**AVERETTE & JONES DAIRY MIXED USE**

DATE:	01-13-2023
SCALE:	AS SHOWN
DESIGNED BY:	FLM
APPROVED BY:	
PROJECT NO.:	21040

SKETCH PLAN

**C-1**  
SHEET 1 OF 1

**TYPICAL INTERIOR ROADWAY CROSS-SECTION**  
NO SCALE

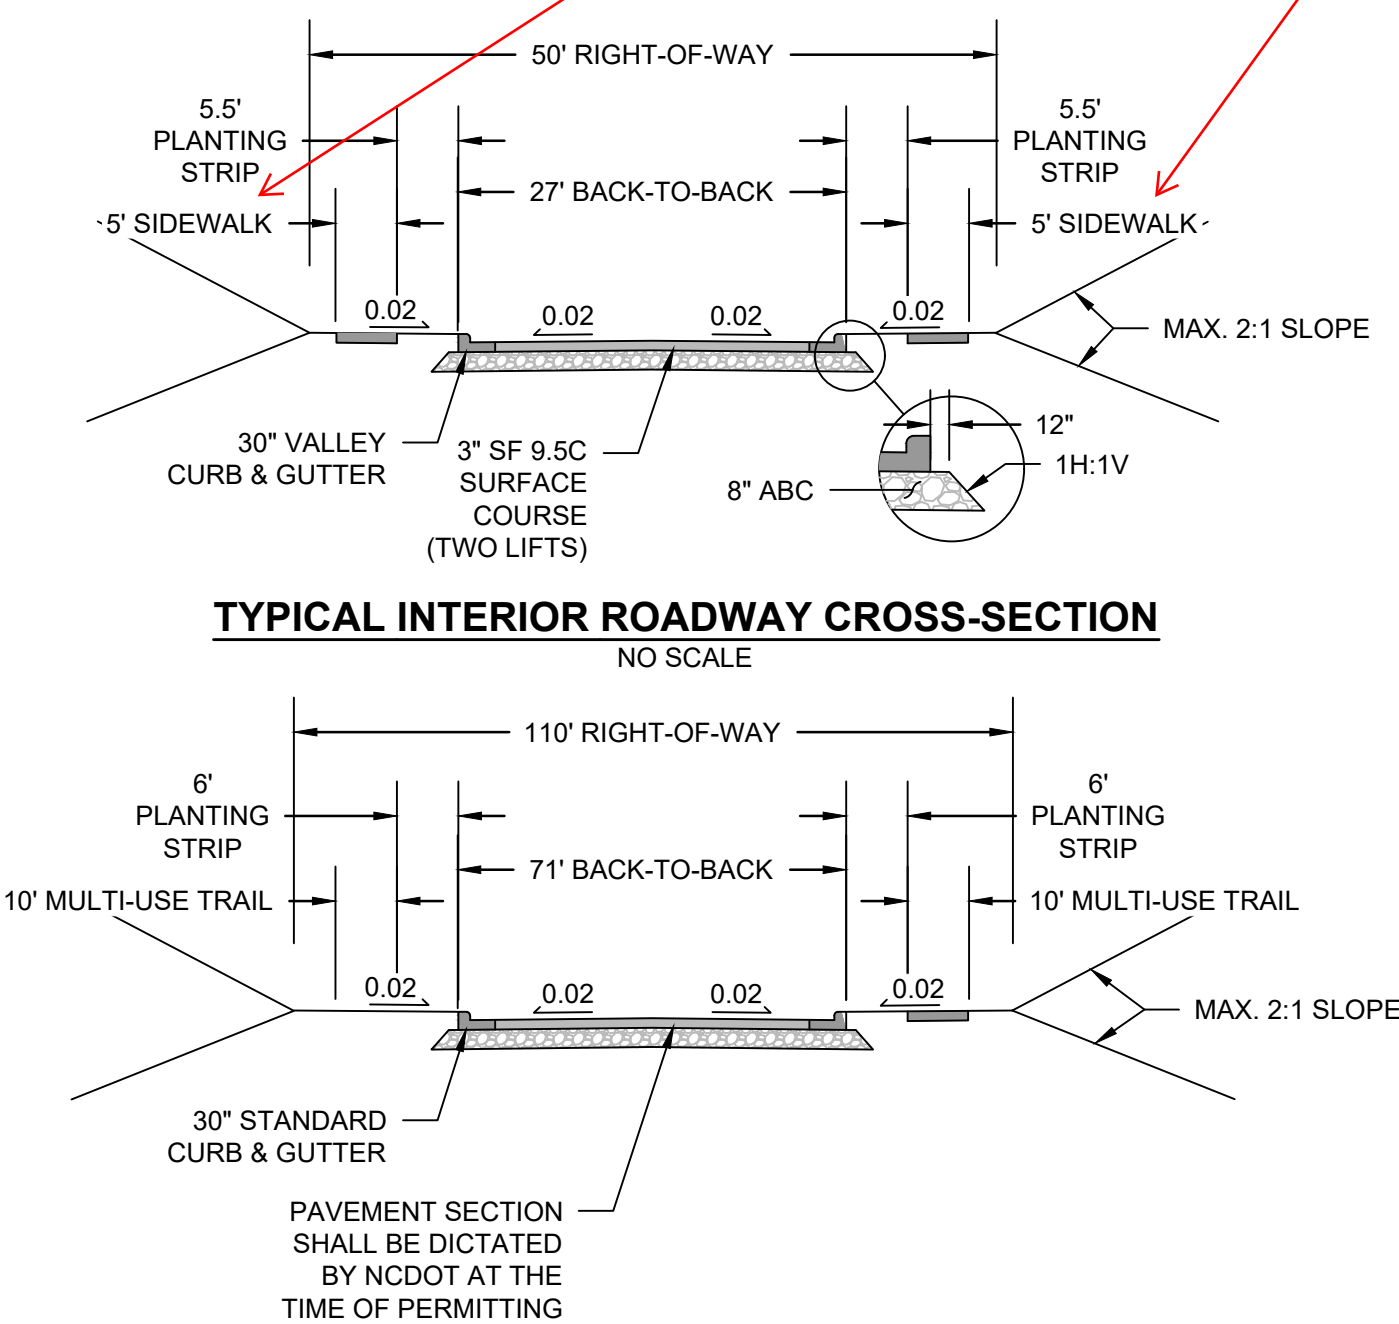
#1 - Sidewalk is called out as 5' here but 6' on the plan view with a "typical" comment. Please confirm if they are different for residential vs. commercial.

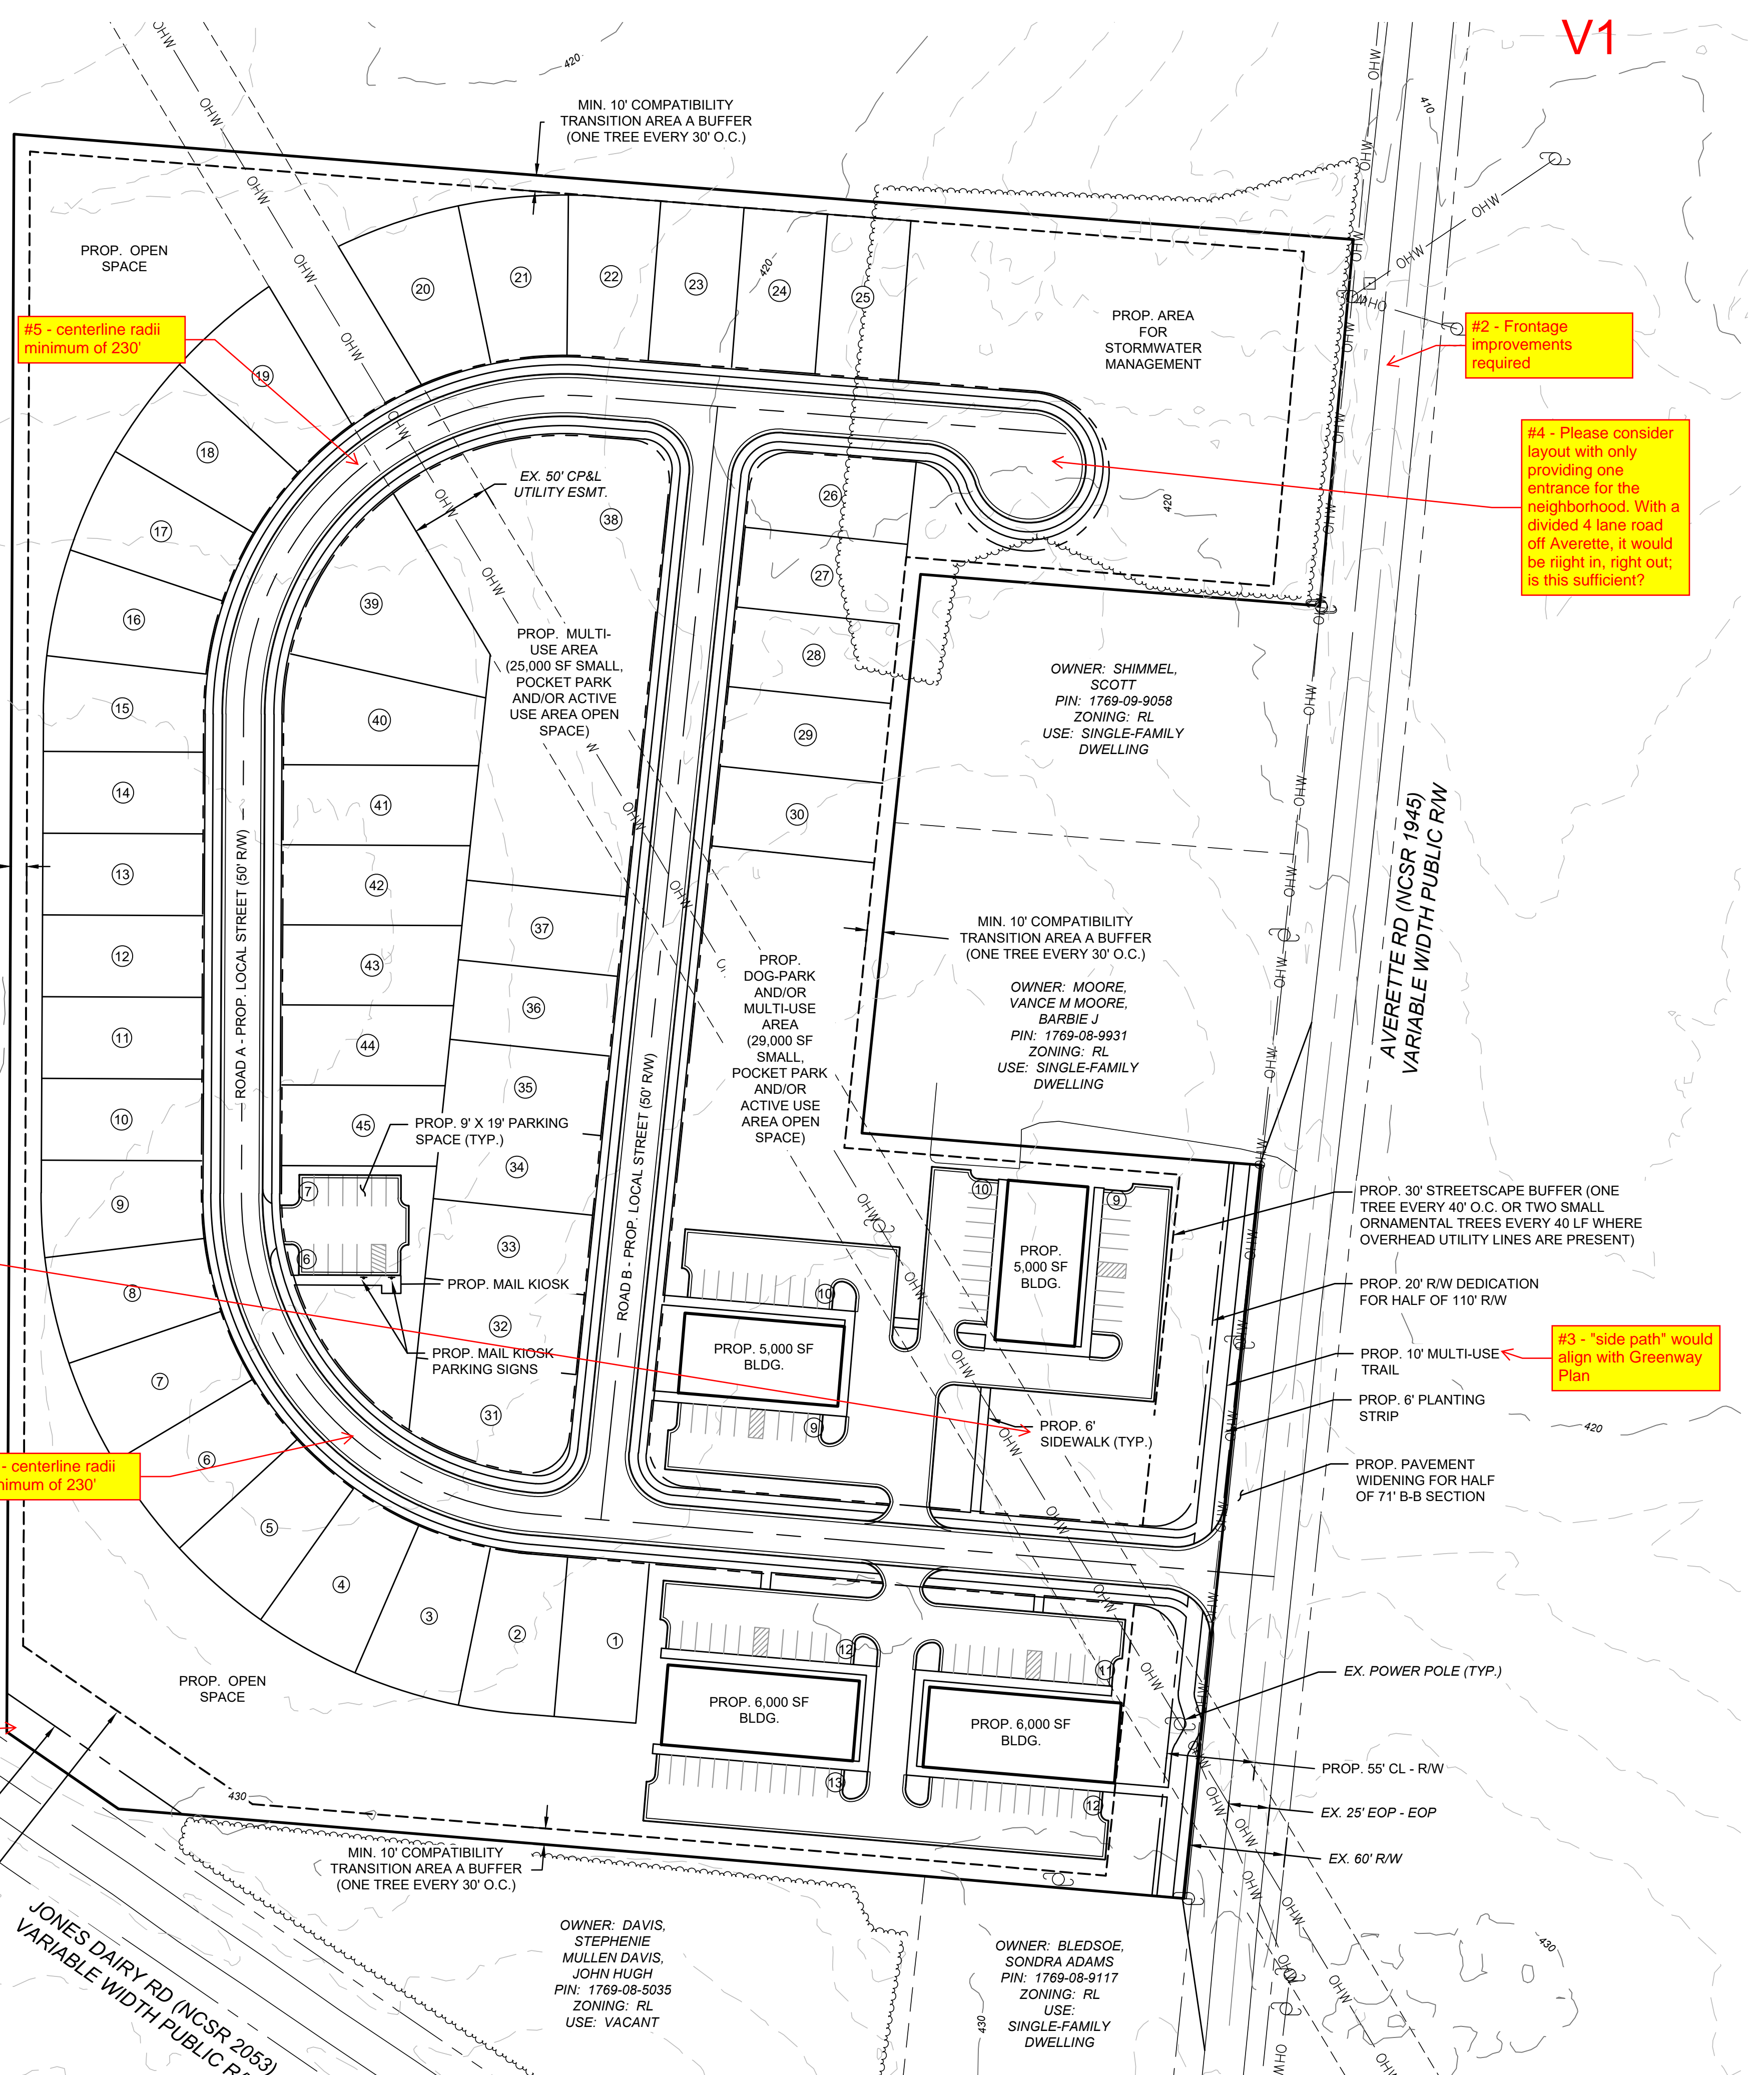
#2 - Frontage improvements required

#5 - centerline radii minimum of 230'

#2 - Frontage improvements required

#4 - Please consider layout with only providing one entrance for the neighborhood. With a divided 4 lane road off Averette, it would be right in, right out. Is this sufficient?

#3 - "side path" would align with Greenway Plan
